RFI #: 135
 Date: 5/31/2012
 Job: EB-02 Keller Springs Lofts
 Phone: 877-777-5115

Subject: Slab at Club Poured Short

RFI #: 148
 Date: 6/8/2012
 Job: EB-02 Keller Springs Lofts
 Phone: 877-777-5115

Subject: Great Room TV / Proper Rating for Wall

Drawing: S2.11, S2.13, A9.1
 Cost Impact: None
 Spec Section:
 Schedule Impact: None

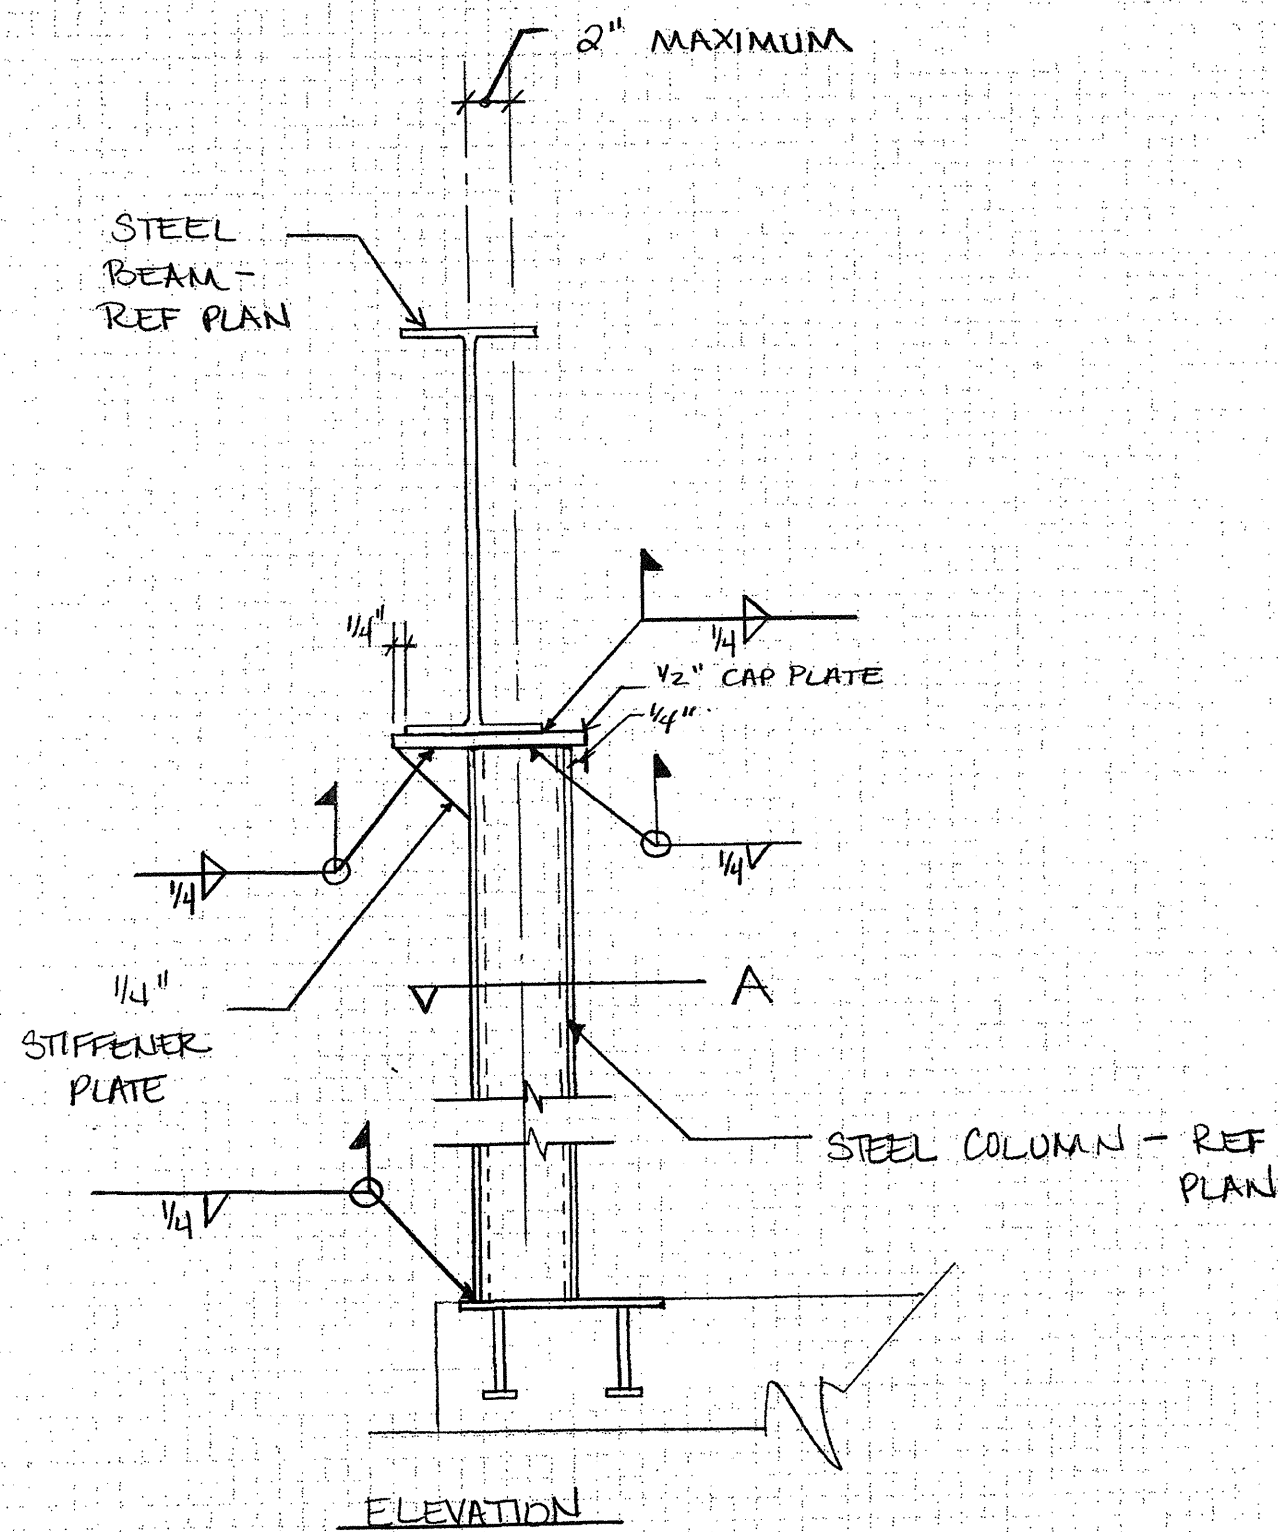
Request:
 On the courtyard side of the Club, where the 45 degree angle is, the concrete slab form board was about 2 inches short right in the angle. Please provide a fix for the following:
 1. How can the steel beam be positioned to carry the exterior wall of the floors above?
 2. How can the slab be repaired so that we have the correct dimensions for the exterior wall of the clubhouse?

Response:
 Per the conference call on May 30, 2012, the beams will remain in the current locations indicated on the drawings and modifications made per the attached sketches. The columns will be attached to the embed plates at their current locations. The maximum offset of the column from its intended location on the structural drawings is two (2) inches. If this limit cannot be maintained with the current locations of the embeds, contact PPO for additional remedial recommendations.

Drawing: A9.1, 4/ID7.0 & 3/ID7.2
 Cost Impact: None
 Spec Section:
 Schedule Impact: None

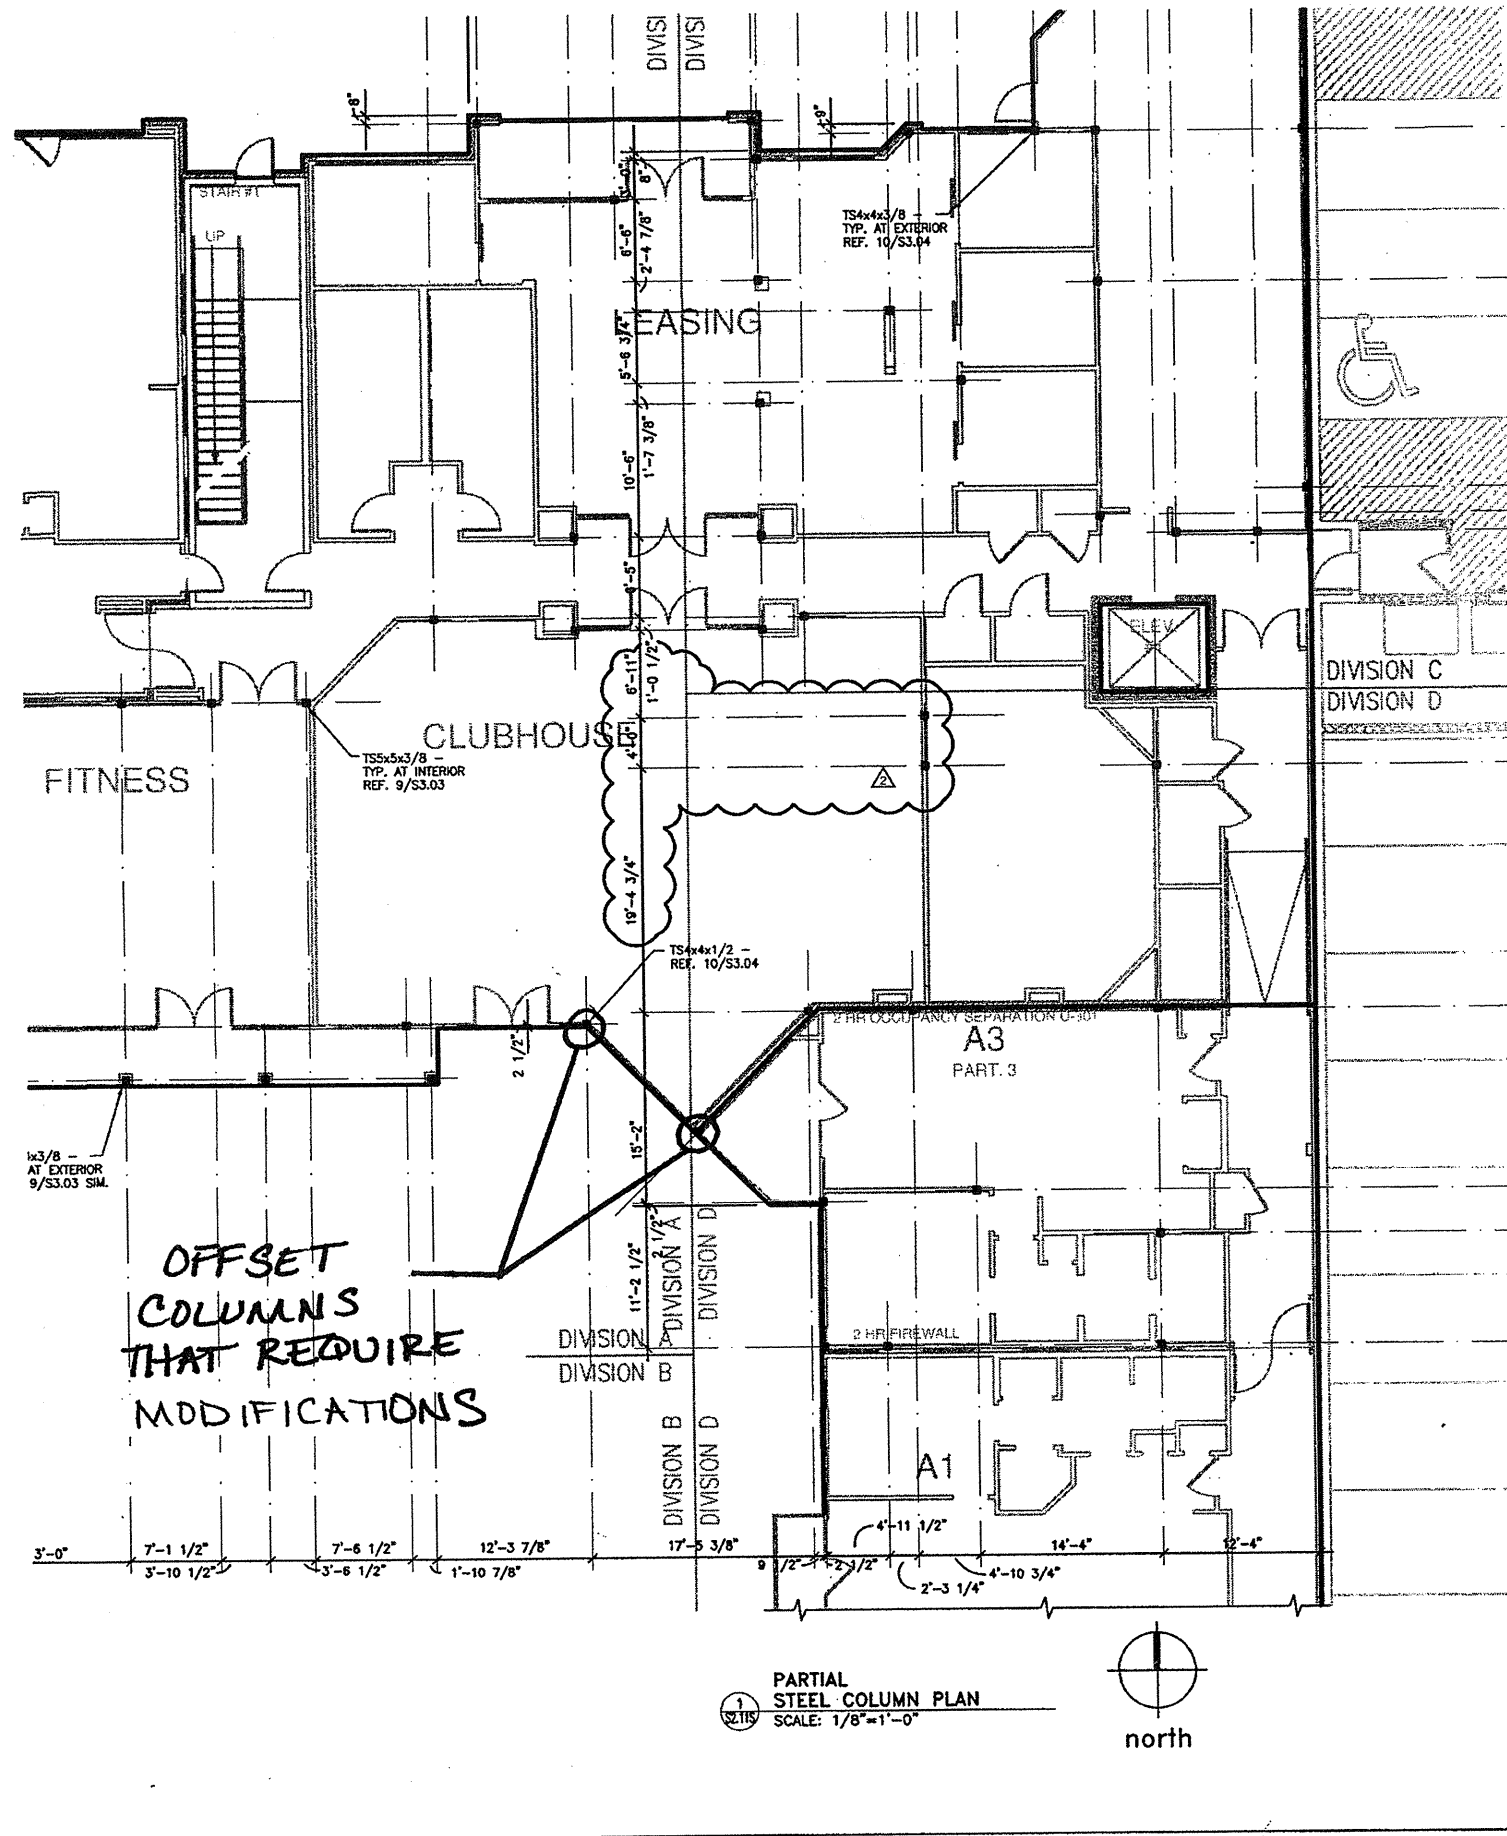
Request:
 Please confirm that we have the rating we need for the 2 HR separation wall as it is drawn by in Interior Designer. Please see the attached drawings.

Response:
 There are two stud walls in this area, and working with Les Wagoner (Embrey), we have coordinated that the 2hr UL wall assembly will go on the unit side stud wall in this area to allow for ID's detail to not affect the 2hr assembly. Les has confirmed that the 2hr assembly will be continuous around the club no matter which direction the 2hr wall turns.
